S E R V I C E N O T E

8922A GSM RF Test Set

Recommended Removal of Hardware

FIGURE 1
Top Internal View of HP 8922A/B/E/G

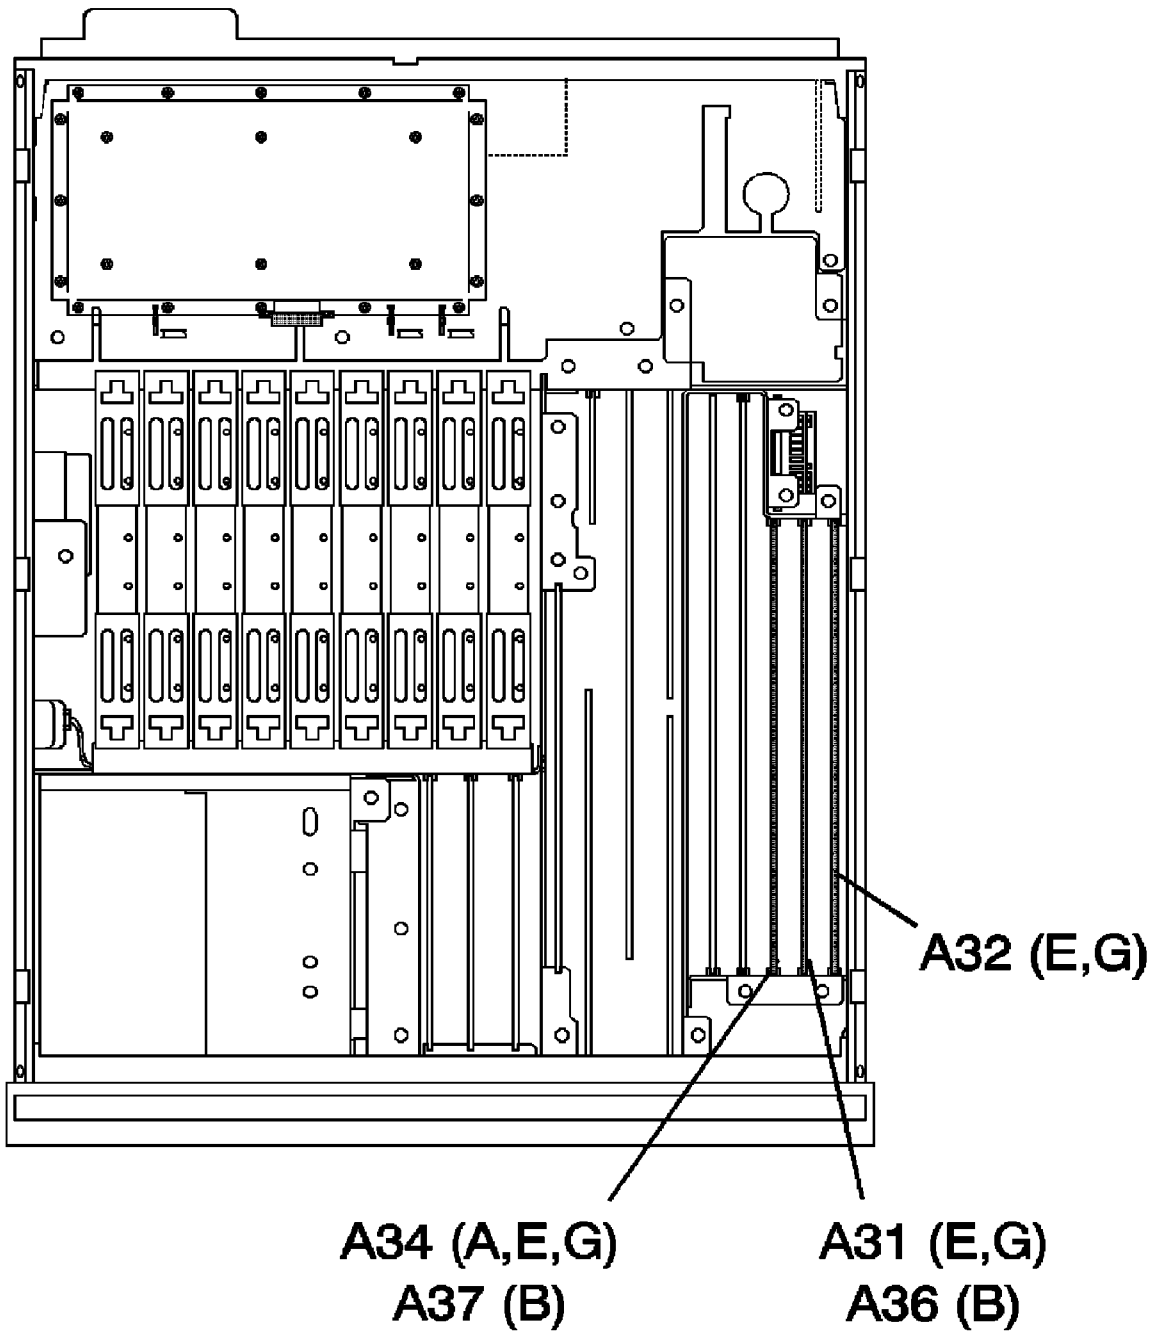
Instruments with serial numbers noted above may have internal hardware (screw and nut) which is improperly attached to the A34 RTI Bypass Assembly. Refer to Figure 1 for location of this assembly. The hardware can become separated from the assembly, contact other circuitry and may cause electrical damage.

FIGURE 2
Location of Excess Screw and Nut Hardware

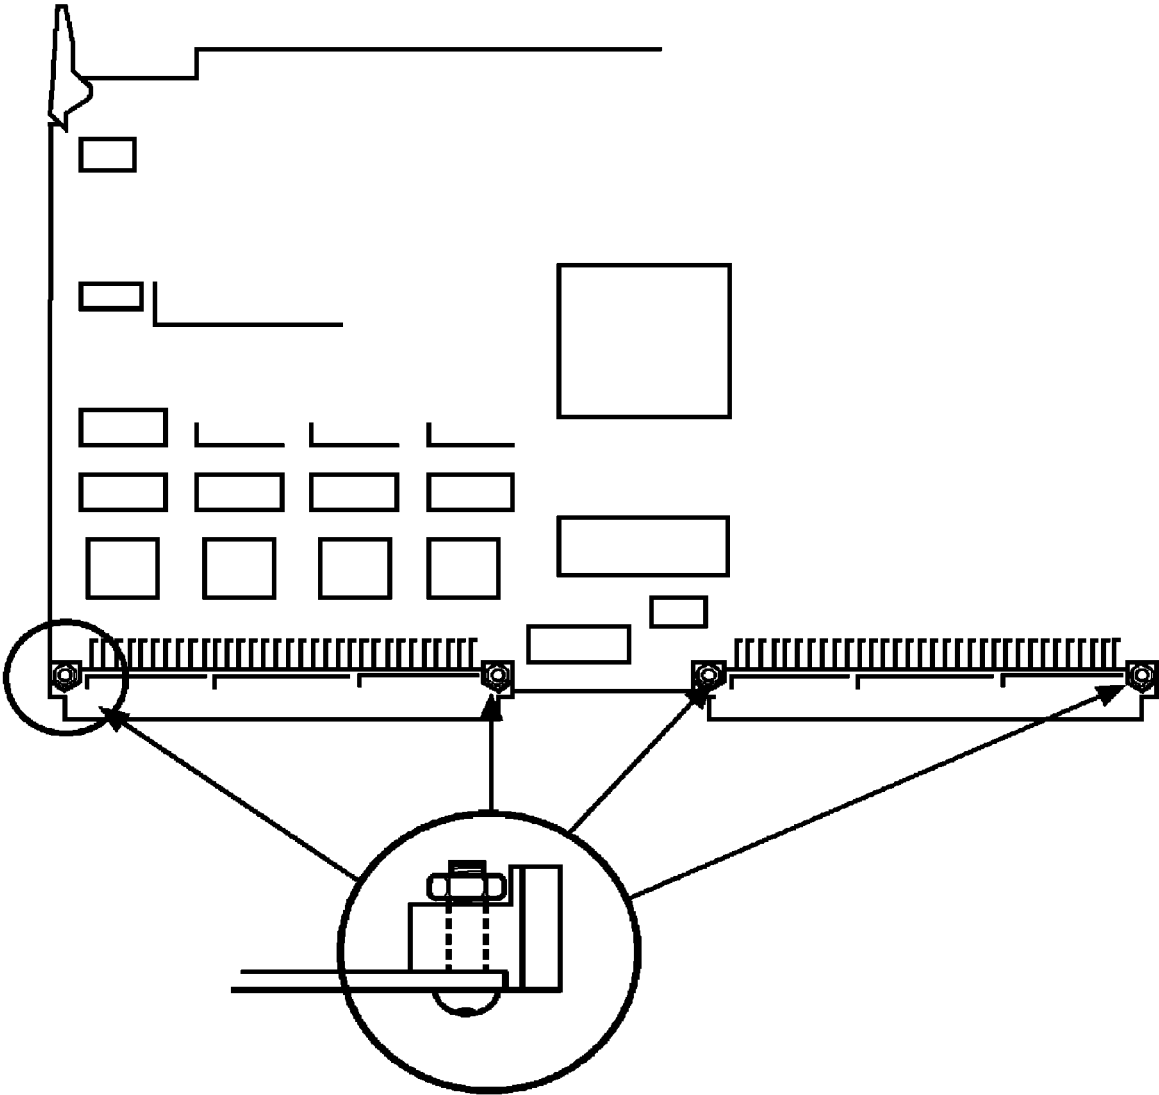
Remove and discard the hardware. Specific locations are indicated in Figure 2. Check for and remove any loose hardware within the instrument. Re-calibration is not required.
